### **REMARKS**

### **Drawing Changes**

Annotated Marked-Up Drawing  
for Examiner's Approval

FIG. 7

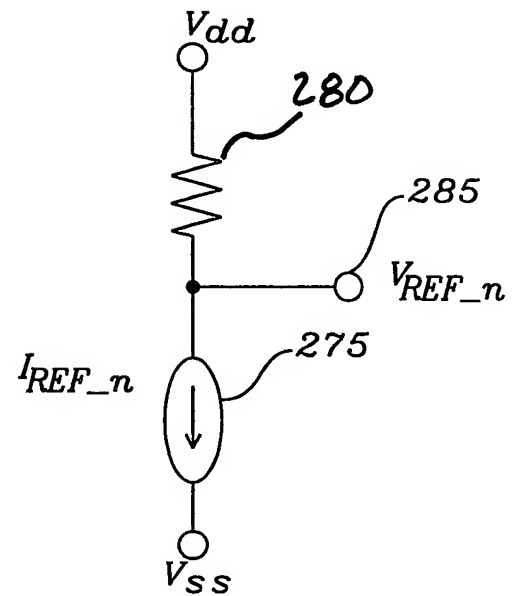
Paragraph 42 of the specification refers to a reference resistor 280, but the resistor in Figure 7 was unnumbered. Applicant proposes adding a reference number 280 and lead line to Figure 7.

FIG. 8

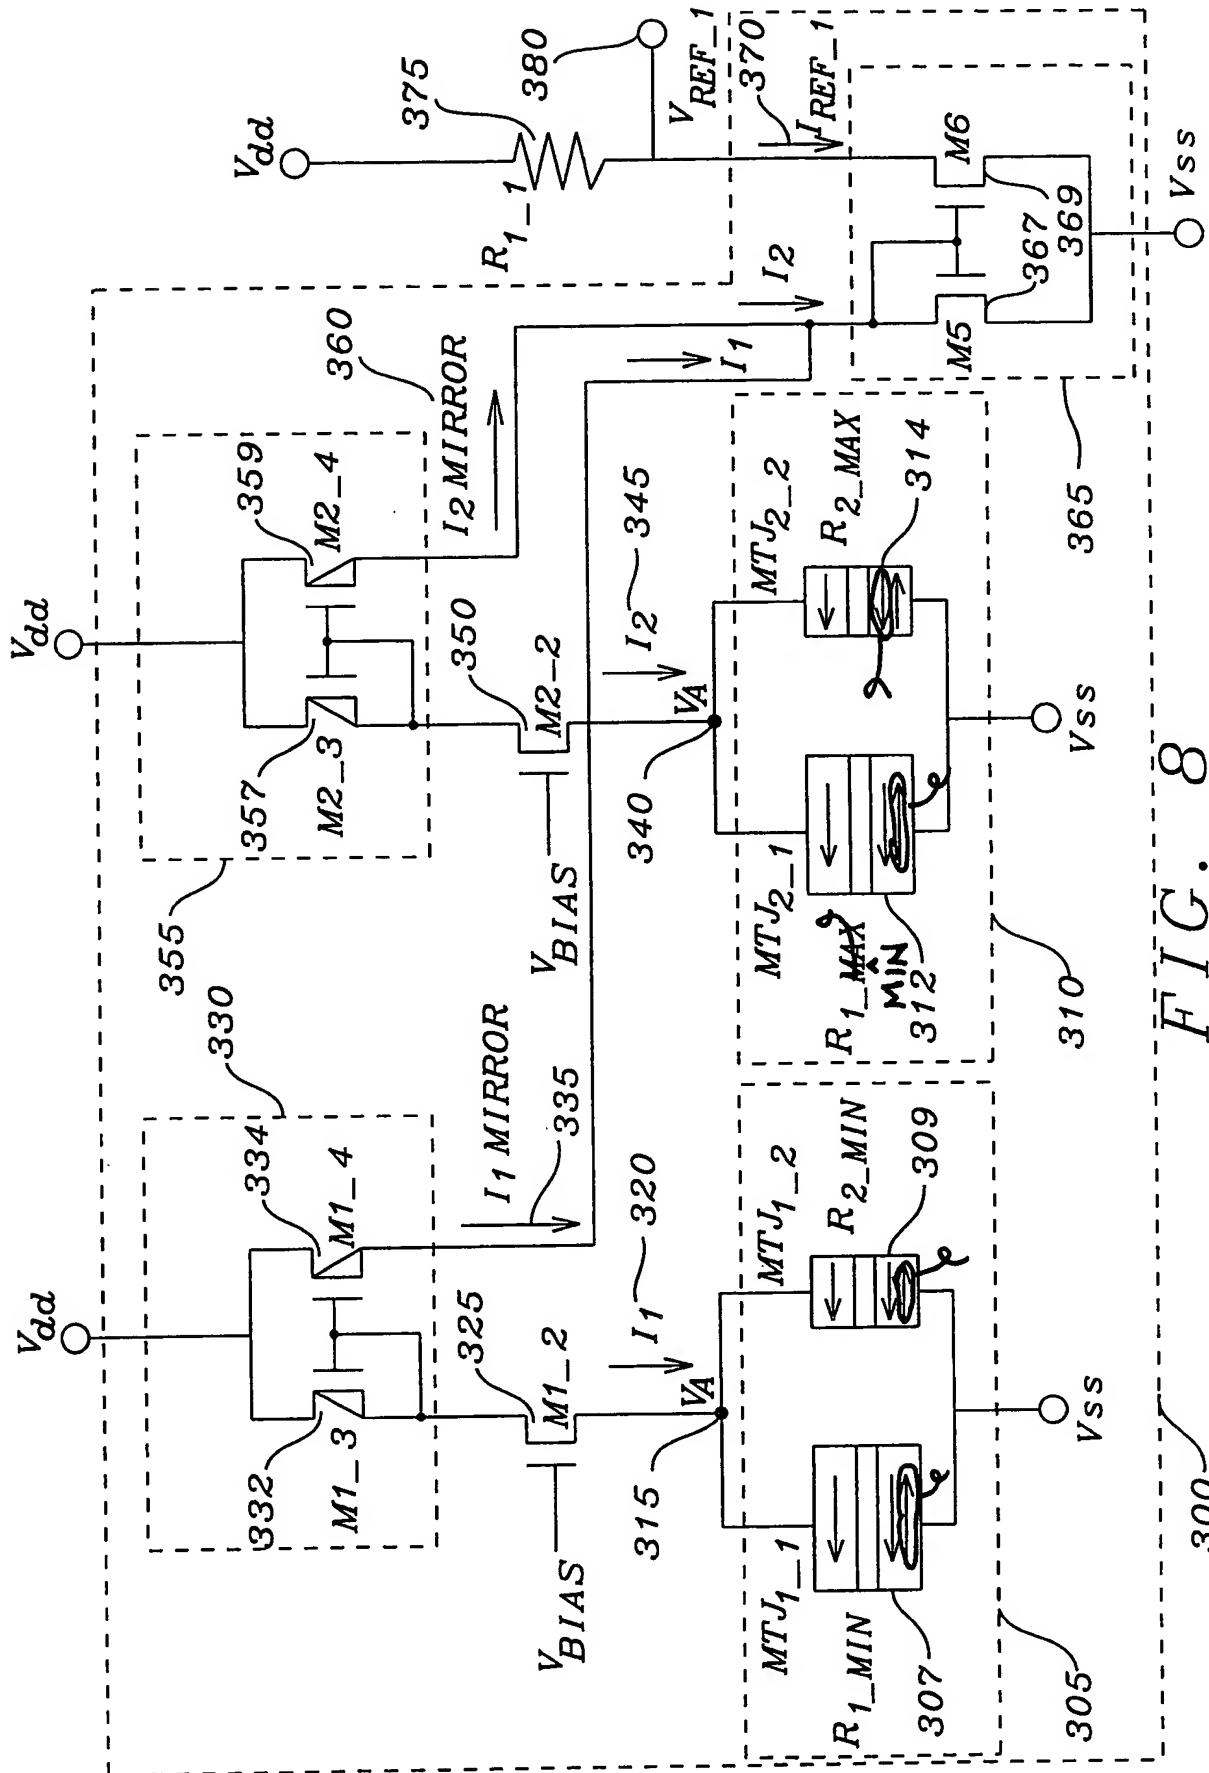
In Figure 8, Applicant proposes modifying elements 305 and 310 to conform to the description in the specification. Paragraph 43 describes that "MTJ devices 307 and 308 have their magnetic fields set to be parallel." Applicant proposes modifying the appearance of MTJ devices 307 and 309 to agree with Figure 10d MTJ devices 205 and 210, showing parallel magnetic fields. Further, paragraph 46 describes that "MTJ devices 312 and 314 have their magnetic fields set to be such that the MTJ device 312 is parallel and the MTJ device 314 is anti-parallel." Applicant proposes modifying the appearance of MTJ devices 312 and 314 to agree with Figure 10c MTJ devices 205 and 210, showing parallel and anti-parallel magnetic fields, respectively. Further, it is proposed that the caption on MTJ 312 be amended to correct a typographical error and place it in agreement with Figure 10c—the caption  $R_{I\_MAX}$  should correctly read  $R_{I\_MIN}$ , as shown in Figure 10c and described in paragraph 37. No new matter is
